Rep No. B18079

Fuji Electric FA Components &  
Systems Co., Ltd.

## Notification regarding Change in Shape of NEO SC Series Optional Three-Phase Parallel Terminal Plates

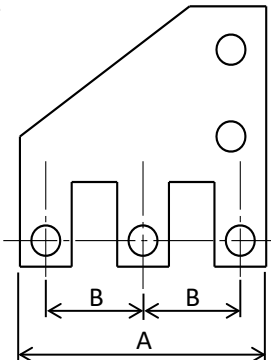
Product name	Three-phase parallel terminal plates										
Series name	NEO SC Series										
Types	SZ-SP8 (For SC-N8, SC-N10)										
Changed parts	Some of the shapes										
Details of the change	<p>The external size and mounting pitch of the product will be changed.</p>

<table><tr> <th>(mm)</th> <th>Conventional product</th> <th>Changed product</th> </tr><tr> <td>A dimension</td> <td style="text-align: center;">125</td> <td style="text-align: center;">119</td> </tr><tr> <td>B dimension</td> <td style="text-align: center;">48.5</td> <td style="text-align: center;">47</td> </tr></table>

(mm)	Conventional product	Changed product	A dimension	125	119	B dimension	48.5	47
(mm)	Conventional product	Changed product									
A dimension	125	119									
B dimension	48.5	47									
Reason for change	To optimize the external product shape to accommodate mold changes (replenishing mold)										
Date of the production change	Scheduled for products to be produced from July 2019.										
Attachment	None										
Notes concerning the change	This change does not have any effect on product performance or specifications.
